**PLANNING DIVISION REPORT  
DEPARTMENT OF PLANNING AND COMMUNITY  
AND ECONOMIC DEVELOPMENT**

**RE: I.D. #11788: Zoning Map Amendment I.D. 3387, Rezoning of 1421 MacArthur Road from R1 to R2**

DATE: September 15, 2008  
TO: Plan Commission  
FROM: Larry D. Nelson, P.E., City Engineer  
SUBJECT: 1421 MacArthur Road Rezoning

**Figure 1: Existing lot widths for single family homes along the 1300 and 1400 blocks of Mac Arthur Road**

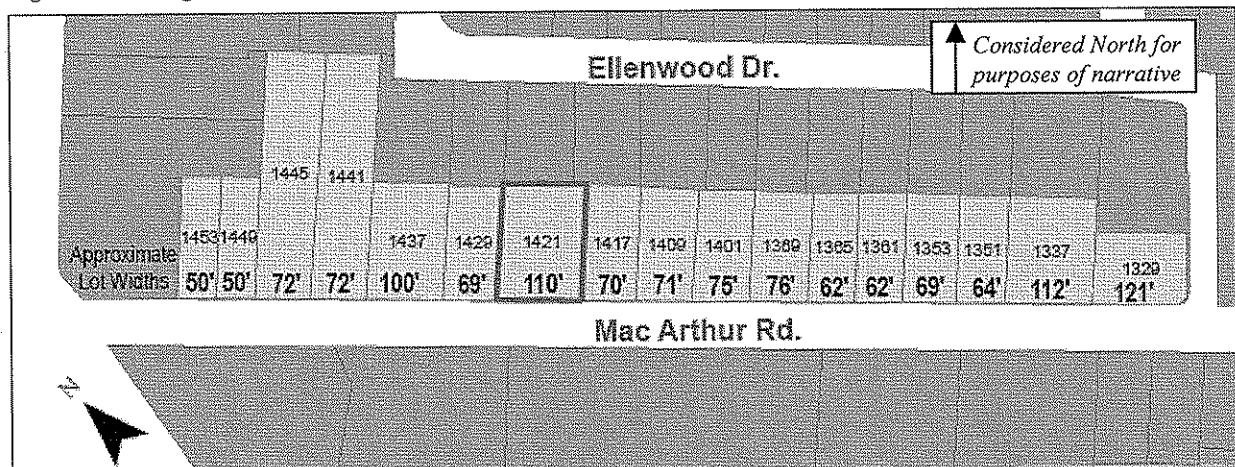
The subject lot is wider than most residential lots in the immediate area. The thirty R1 lots on this block of Mac Arthur Rd. and Ellenwood Dr. to the north are approximately 11,800 square feet on average, ranging from 7,900 square feet (0.18 acres) to 24,000 square feet (0.55 acres). Only one is of sufficient size and width to be subdivided under the existing R1 zoning, and only five are adequately wide to accommodate a subdivision if they were zoned R2. As shown in Figure 1, single-family lots with frontage on the 1300 and 1400 blocks of Mac Arthur Road have an average width of 77 feet, and range in width from 50 feet to 121 feet (five of the lots on these blocks do not conform to R1 zoning due to lot widths less than 65 feet).

At approximately 110 feet wide, the subdivision of 1421 Mac Arthur Road would create two lots narrower than most of the others on the block. However, as long as a single-family home built on the new lot in the future generally conforms to others in the area, it might not significantly affect the rhythm of the block or the overall character of the neighborhood. Unfortunately, the applicant has not formally submitted a certified survey map or plans for a new single-family home for the Plan Commission to consider at this time. While indicating that they intend to construct an 800-1,200 square-foot home at some point in the future, it is difficult to assess the tangible impacts of the rezoning without knowing the dimensions of the new lot and exactly what is proposed on the new lot.
